IFB No. 23-23 Kennedy M.S. Roof Replacement

RE: ADDENDUM NO. 2

SUBJECT: RPS 205 KENNEDY M.S. ROOF REPLACEMENT
ROCKFORD, IL
ARCHITECT PROJECT #21-13910

CLARIFICATIONS TO THE DRAWINGS DATED: 09/12/2022

KENNEDY KEY PLAN
NTS

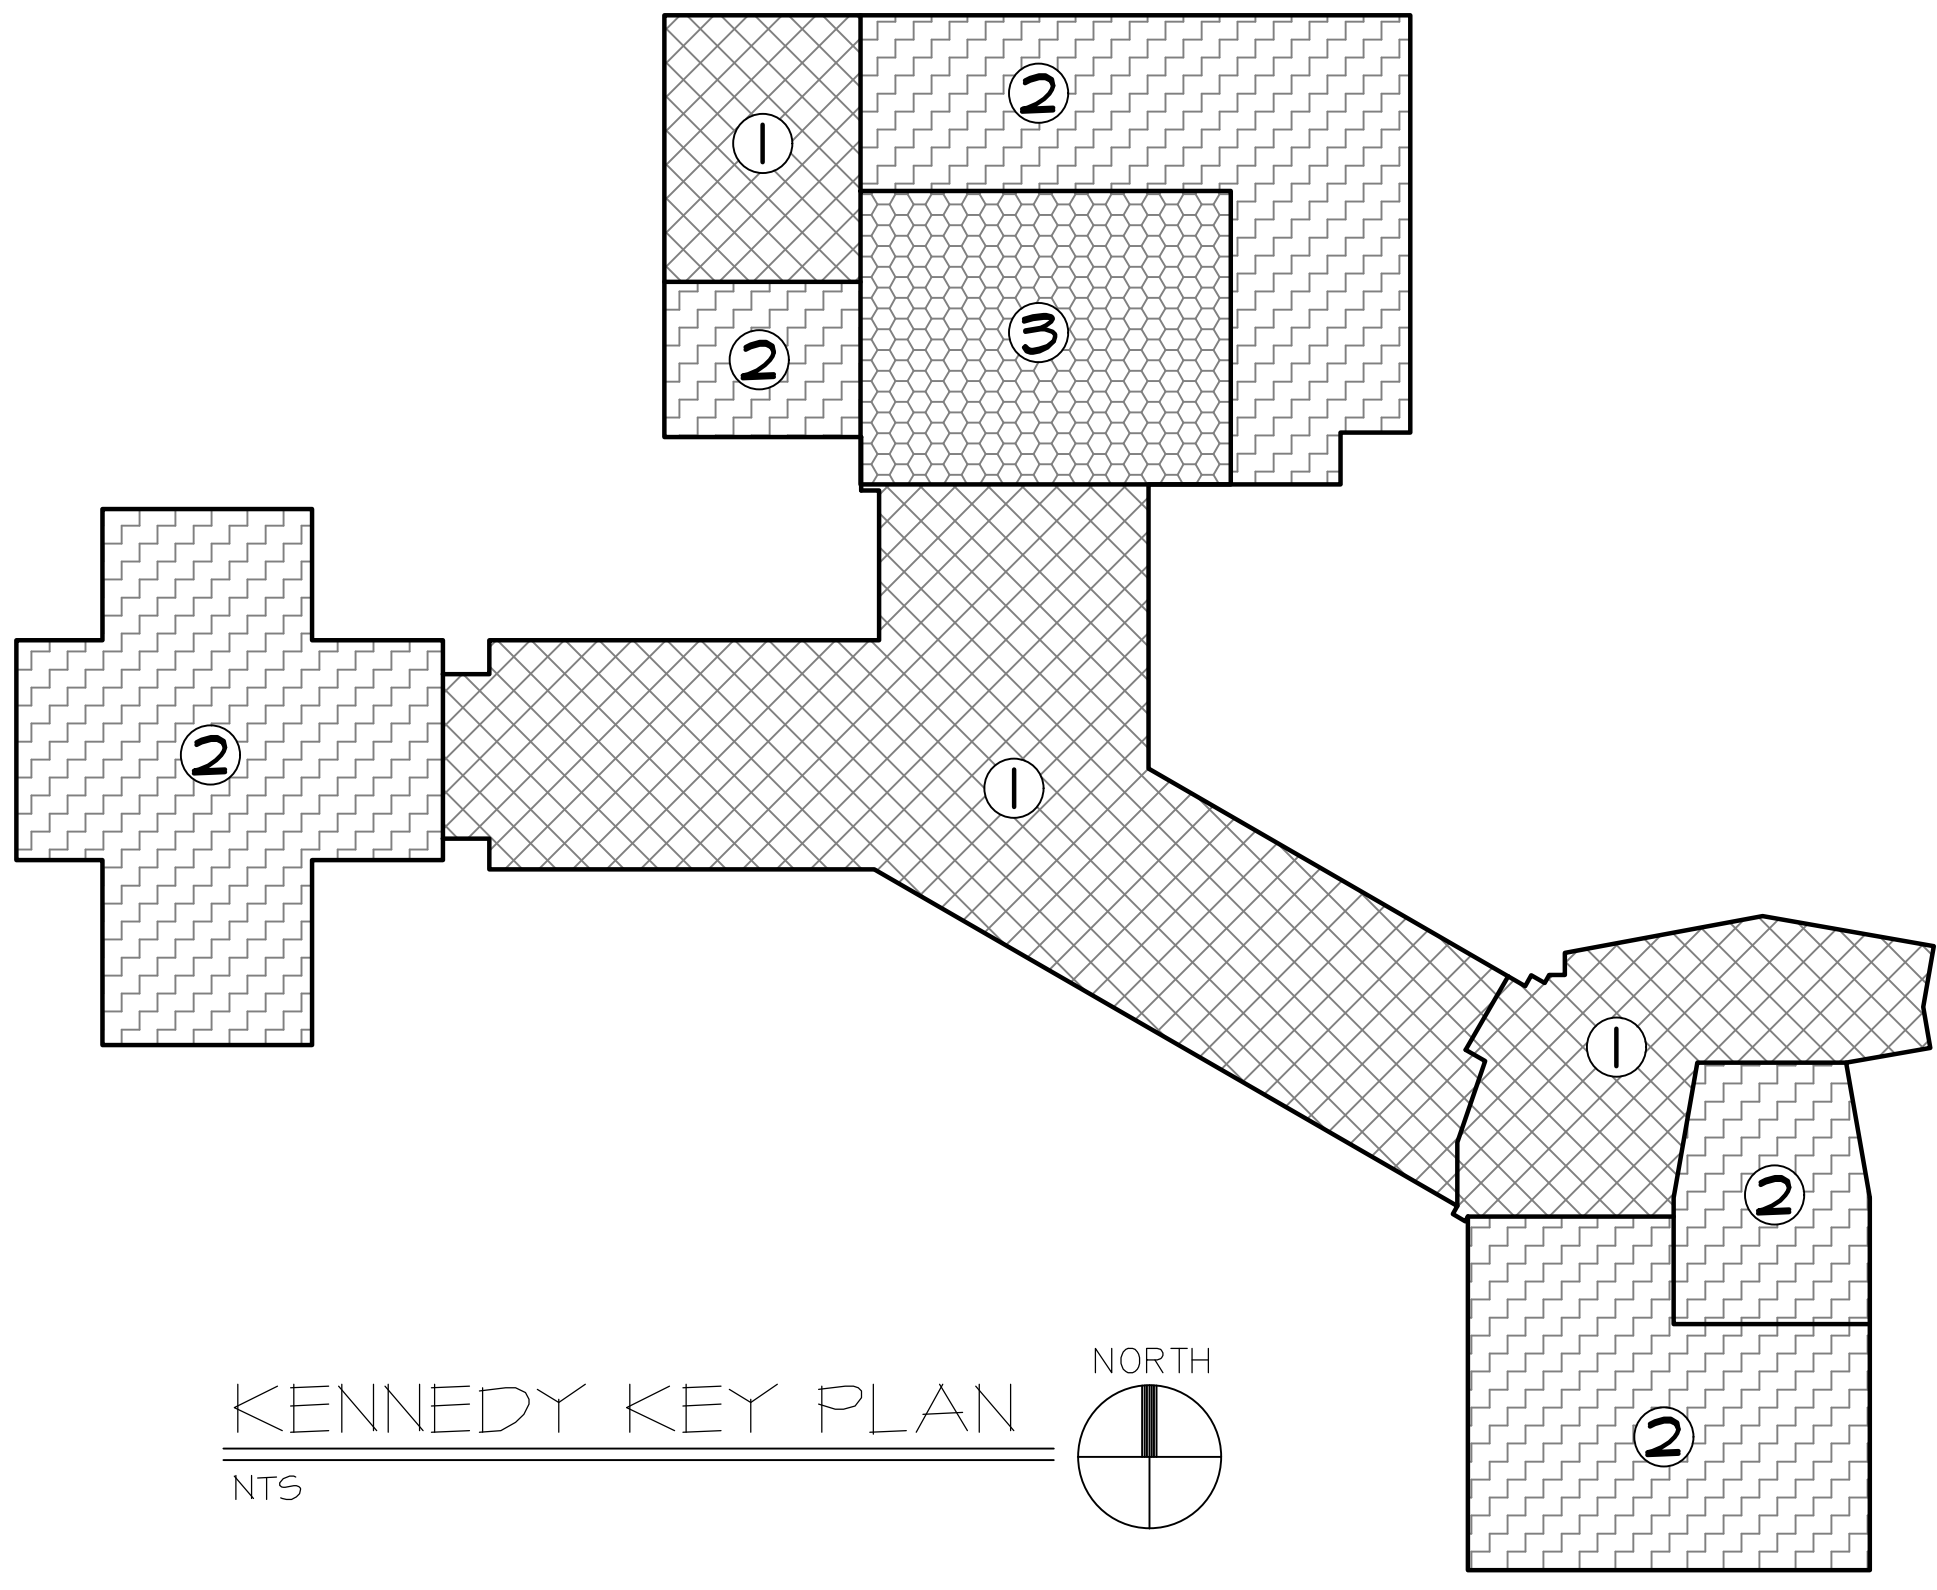
G-1.0: Keyplan showing roof construction information and roof area scope of work added.

- ① AREA OF EXISTING MECHANICALLY FASTENED, BALLASTED MEMBRANE ROOF - MEMBRANE POLYISO AND COVERBOARD IS TO BE COMPLETELY REMOVED TO DECK AND REPLACED. BALLAST ROCK IS TO BE COMPLETELY REMOVED FROM EXISTING ROOF AND TO BE DISPOSED OF OR TURNED OVER TO USING AGENCY. NEW ROOF WILL BE MECHANICALLY FASTENED TPO, PER DETAILS, OVER R-30 (MINIMUM) INSULATION VALUE AND NEW COVERBOARD.
- ② AREA OF EXISTING MECHANICALLY FASTENED MEMBRANE ROOF (NON-BALLASTED) - MEMBRANE, POLYISO AND COVERBOARD IS TO BE COMPLETELY REMOVED TO DECK AND REPLACED. NEW ROOF WILL BE MECHANICALLY FASTENED TPO, PER DETAILS, OVER R-30 (MINIMUM) INSULATION VALUE AND NEW COVERBOARD.
- ③ AREA OF ADHERED MEMBRANE ROOF (NON-BALLASTED) - MEMBRANE, POLYISO AND COVERBOARD IS TO BE COMPLETELY REMOVED TO 4-PLY AND REPLACED. NEW ROOF WILL BE ADHERED TPO, PER DETAILS, OVER R-30 (MINIMUM) INSULATION VALUE AND NEW COVERBOARD.

*ALL ROOF BALLAST TO BE REMOVED AND DISPOSED OF.
* ALL ROOF PERIMETER BLOCKING IS TO BE REPLACED

KENNEDY ROOF PLAN
Rev. Date
10-06-22
Sheet No.
A-1.0

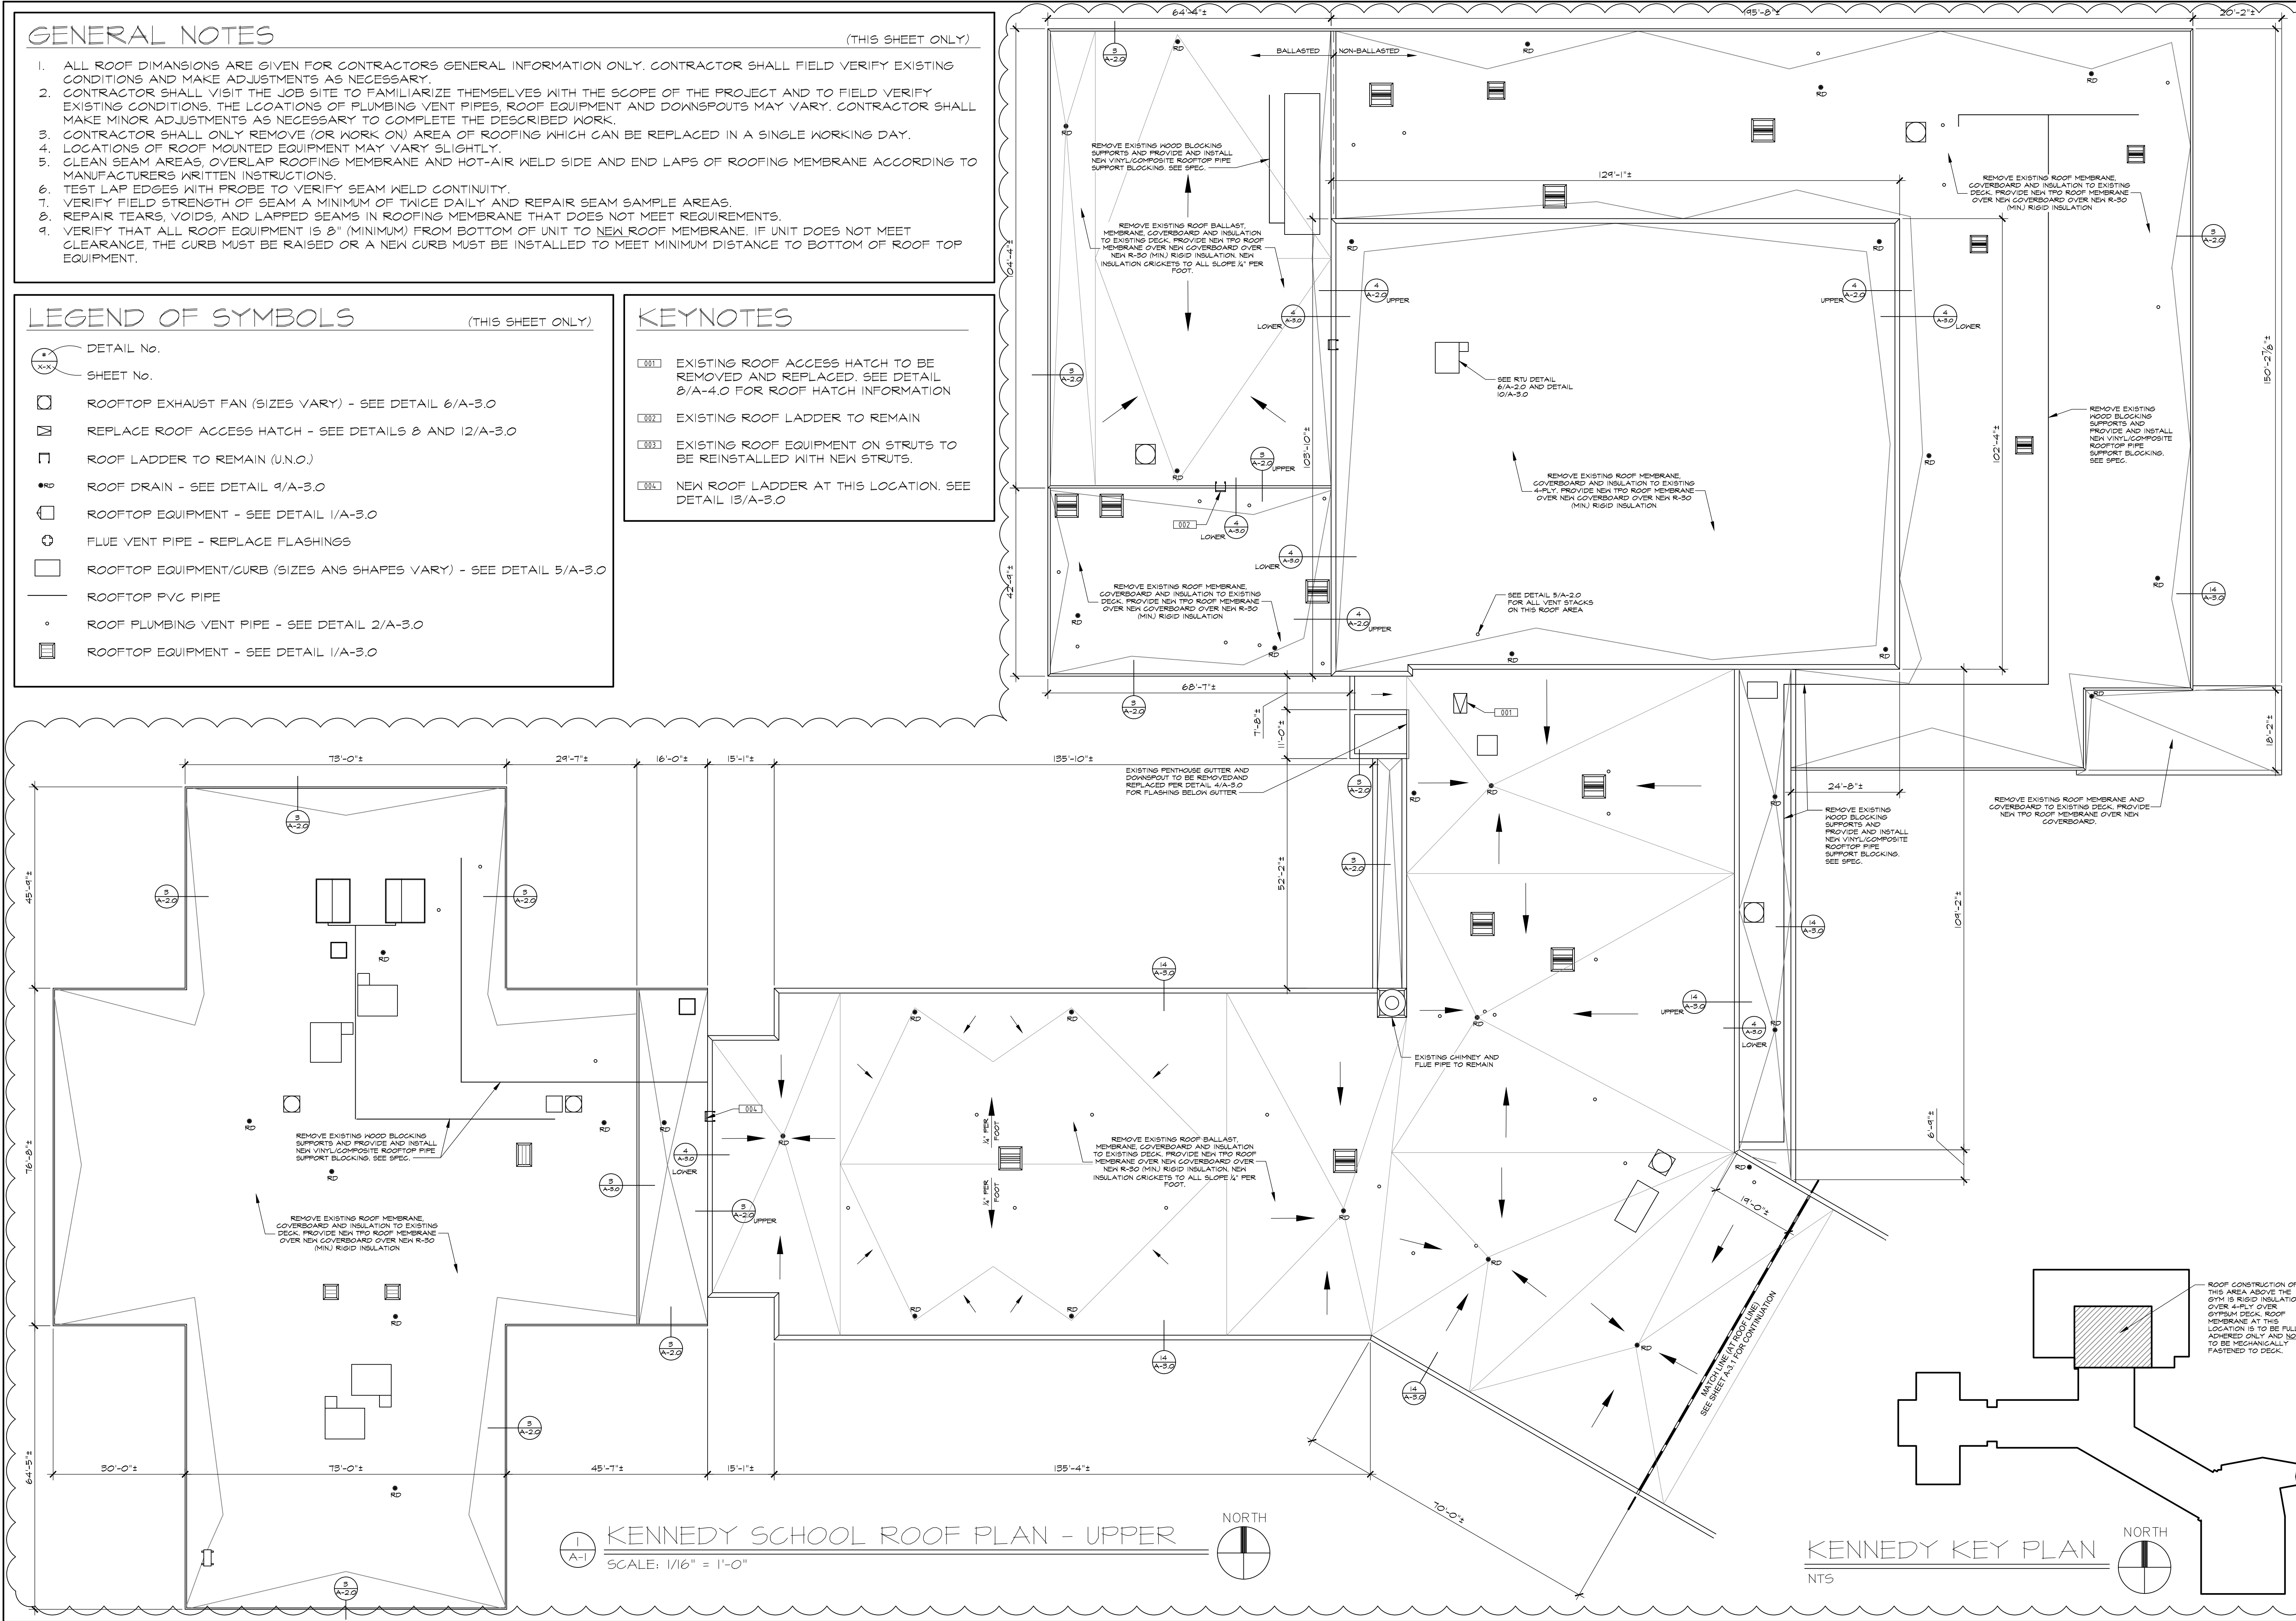
A-1.0: Changes to the upper roof plan include:

1. Roof edge detail reference number changes due to removal of ballasted edge Detail (2/A-2.0).
2. General remove and replace notes added to roof areas for clarification.
3. Roof drain count and locations changed.
4. Roof crickets added to previously ballasted roof areas due to the discovery of ponding water (very flat area(s)). R-30 minimum insulation value noted.
5. Roof ladder locations and counts have changed.
6. Roof top piping blocks (currently wood blocking) now shown and noted.
